Interactive comment on “The formation processes and development characteristics of sandbars due to outburst flood triggered by landslide dam overtopping failure” by Xiangang Jiang et al.

Response to the Reviewer 2 Summary: The authors use a flume study to understand the effects of outburst flooding on downstream sandbar development. Different dam geometries (width and downstream slope angle) and a constant dam height were used. The upstream pool was allowed to fill and then overtop and fail under the same constant flow rate in all experiments. The authors relate bar frequency and volume to different dam geometries, and also note that bars tend to grow upstream during the experiments. The authors proceed to relate their observations to the flow hydraulics and sediment concentrations during the experiment. While the experimental set up seems

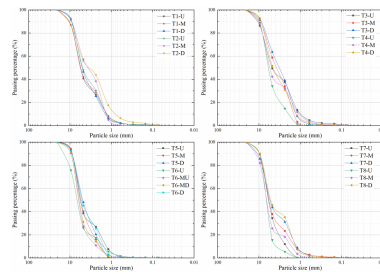
Section 3: It would be very useful to have some information on grain size on the bars in this section. Much of the sediment in the experiment seems equivalent to boulders in the field case, and the coarse sediment seems to comprise much of the bar material. Even in that case, the grain size of the sediment is going to be a very important factors in depositional patterns and should also be reported.

We fully agree with the reviewer's opinion. We report the material size information of the boulder bar downstream of the river bed (section 5 in the revised manuscript). We found that the farther away from the dam, the smaller the median particle size of the boulder bar material for the boulder bar on the river bed. The experimental results are in good agreement with the Yigong flood (Turzewski et al., 2019). We have added the related descriptions and explanations in the 3th paragraph of section 5. The details are as follows: "Turzewski et al. (2019) measured the sizes of boulder bars. They found that grain sizes of boulder bars decrease downstream. In this experiment, boulder bar materials from different river bed sections were collected. And after screening and analysis, it was found that as the distance between the boulder bar and the dam increases, the particle diameter in the bars shows a decreasing trend, as shown in Fig. 10. This feature is consistent with the description of Turzewski et al. (2019).
